# Access Compliance Report

## Public Rights-of-Way

Intersection ID: 9362	Main Street: DELTA_LAKE_DR	Cross Street: ROCKMOOR_RIDGE_RD	Location: SW
ADA ID: C20CD664D8FA	Ramp Type: BlendTrans1	Initial Pass/Fail: Fail	Overall Compliance: No
		Severity Score: 8.75

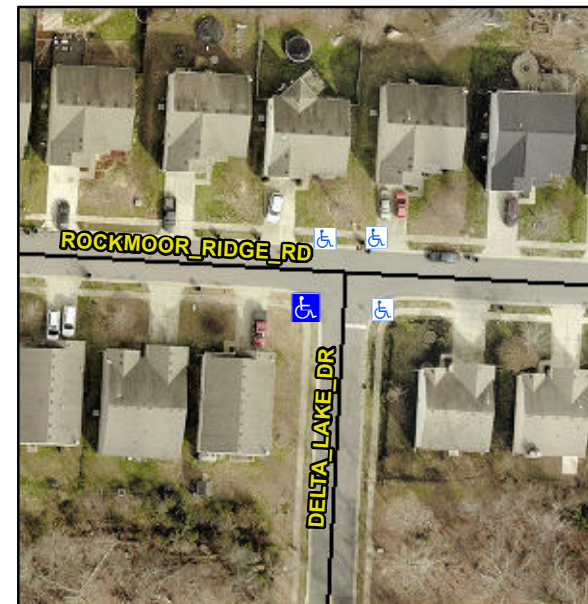
**CURB LIP 1.5**

**Not Found, R304.5.1**

**Remove & Replace Curb Ramp With Two New Directional Ramps or Equivalent.**
